Global Nuclear Fuel

October 28, 2004

Subject: Response to NRC Questions Regarding Stress on Fuel, Basis for Selecting Container Orientation for Testing and Wording in SAR Relating to Damage During HAC Test

Attachment 1

Figure 6-5 RAJ-II Container Cross-Section Normal Conditions of Transport Model

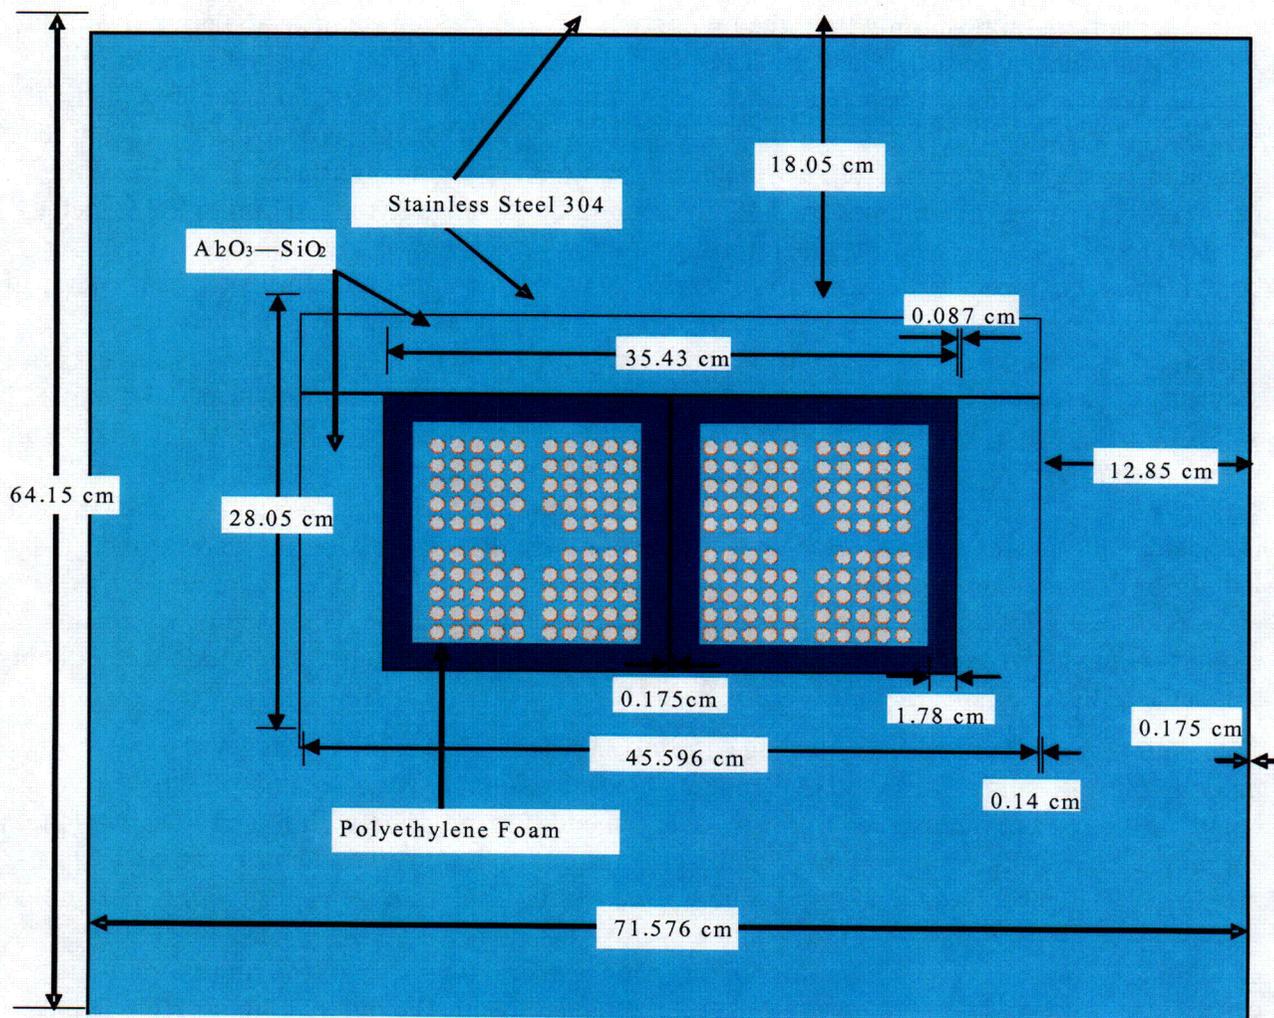
Section 6.3.1.1.2	Clarified text regarding inner container damage.
Table 2-11	Clarified text regarding inner container damage.

6.3.1.1.2 Single Package Hypothetical Accident Condition Model

The RAJ-II HAC model inner container dimensions are shown in Figure 6-7 and Figure 6-8. The container deformation modeled for the RAJ-II HAC model includes the damage incurred from the 9-meter drop onto an unyielding surface as well as conservative factors. The RAJ-II inner container length is conservatively reduced by 8.1 cm to bound the damage incurred from the 9-meter drop onto an unyielding surface. The alumina silicate insulation is assumed to remain in place, since scoping calculations proved it to be a better reflector than water for the worst case moderator conditions considered in the HAC model. The polyethylene foam, present in the normal model, is assumed to burn away when exposed to an external fire. As a result, the fuel assemblies are assumed to freely move within the respective compartment resulting in a worst case orientation. The rubber vibro-isolating devices are also assumed to melt when exposed to an external fire, allowing the inner container to shift downward about 2.54 cm. However, scoping calculations reveal no increase in reactivity by moving the inner container; therefore, the

inner container is positioned within the outer container as shown in Figure 6-8. The inner container horizontal position within the outer container remains the same as the normal condition model, since the stainless steel fixture assemblies remained intact following the 9-meter drop. The outer container dimensions are shown in Figure 6-6 RAJ-II Outer Container Hypothetical Accident Condition Model and Figure 6-8. The outer container length is reduced by 4.7 cm to bound the damage sustained from a 9-meter drop onto an unyielding surface. In addition, the outer container height is reduced by 2.4 cm to bound the damage sustained during the 9-meter drop (Reference 1). No credit is taken for the structural steel between the inner and outer containers. The honeycomb shock absorbers, located between the inner and outer containers, are not explicitly modeled. Instead, water is placed in the space between the inner and outer containers, and its density is varied from 0.0 – 1.0 g/cm³. The honeycomb shock absorbers have a density between 0.04 and 0.08 g/cm³. The hydrogen number densities for water (1.0 g/cm³) and for the honeycomb shock absorber (0.08 g/cm³) are 6.677x10⁻² and 2.973x10⁻³ atoms/b*cm, respectively. As a result, water is more effective at thermalizing neutrons than the honeycomb shock absorbers. Therefore, the use of water at 1.0 g/cm³ between the inner and outer containers is considered a conservative replacement for the honeycomb shock absorbers. The reduction in length for the inner and outer containers, the reduction in height for the outer container, the absence of polyethylene foam, the presence of the insulation, and the fuel assembly freedom of movement are consistent with the physical condition of the RAJ-II shipping container after being subjected to the tests specified in 10 CFR Part 71.
